June 1, 2016  
Palo Alto, California

Mr Glen Martin  
Regional Administrator, Western-Pacific Region  
Federal Aviation Administration

Figure 1 – The 4,000-ft MENLO waypoint is located in a residential neighborhood even though the Bay is less than 2 miles away.

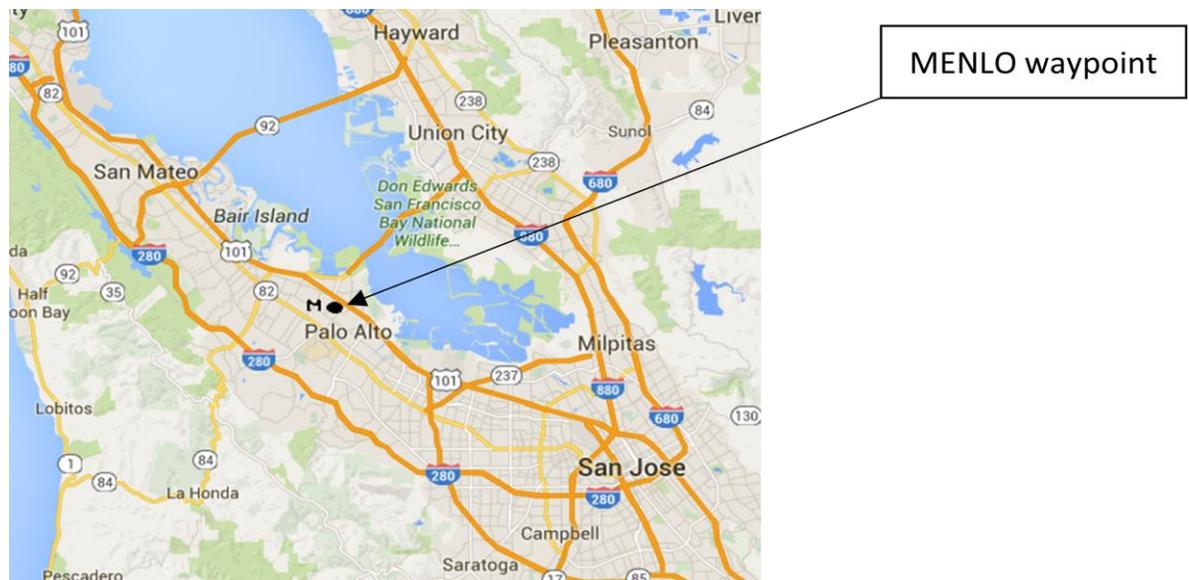
**1. Abandon the use of the MENLO waypoint.**

- a. A 4000-foot waypoint over a densely populated area is unacceptable, unsustainable, and unnecessary when a huge body of water is directly available less than 2 miles away (see Figure 1).
- b. Adopt one or more waypoints east or southeast of MENLO to enable arrivals to fly at higher altitudes over residential areas and take full advantage of the length of the Bay.

Figure 2 - May 2015 radar pings for flights above 3000 feet. Gap areas are indicated by blue arrows.

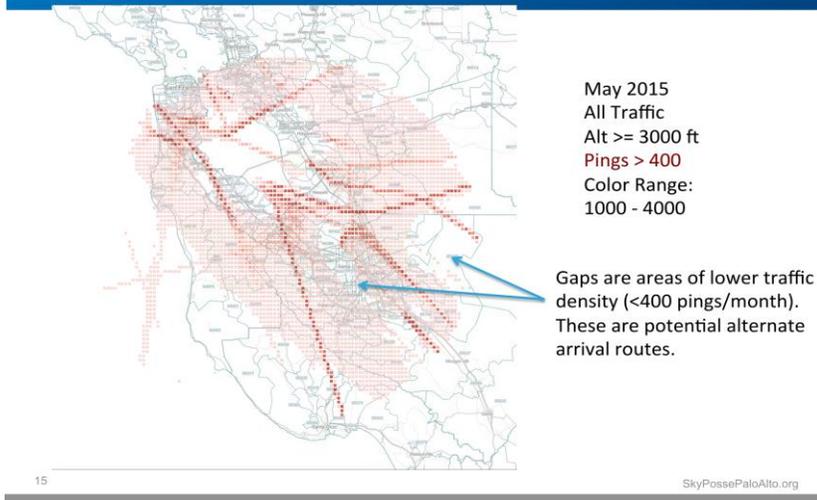
- 2. Direct Pt Reyes arrivals to use primarily the Pt Reyes east leg (over the Bay) for immediate relief. Then address, if necessary, the concentration issue of low altitude Pt Reyes west leg arrivals over Palo Alto.**
- 3. Take advantage of the full extent of the Bay for descents.**
  - a. Guide arrivals from the south up the uninhabited or industrial areas east of the Santa Clara Valley/US 101 so that planes avoid residential areas.
  - b. Then guide arrivals through one or both traffic gaps as shown in figure 2 to get to the Bay for final approach.
